Organ Notes

FREQUENCY RESPONSE - MODEL 500 TONE CABINET

BEFORE CHANGE

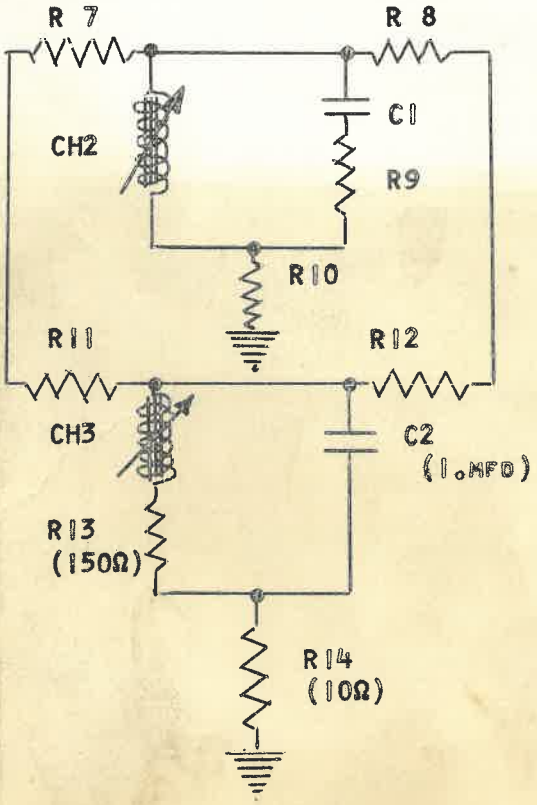
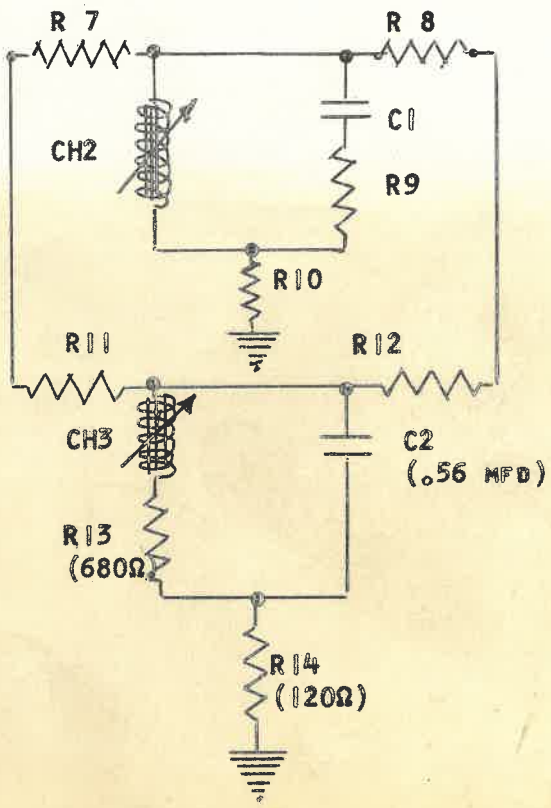
UNDER CERTAIN ACOUSTICAL CONDITIONS, A LACK OF PROPER RESPONSE MAY BE NOTED ON MODEL 500 TONE CABINETS BELOW SERIAL # 393501. THE FREQUENCY RESPONSE CAN BE ALTERED BY CHANGING THREE COMPONENTS IN THE AMPLIFIER AS SHOWN ON THE SCHEMATIC DIAGRAMS BELOW.

1 EACH- 120Ω, ½ WATT RESISTOR
1 EACH- 680Ω, ½ WATT RESISTOR
1 EACH- .56 MFD., 100 VOLT CAPACITOR
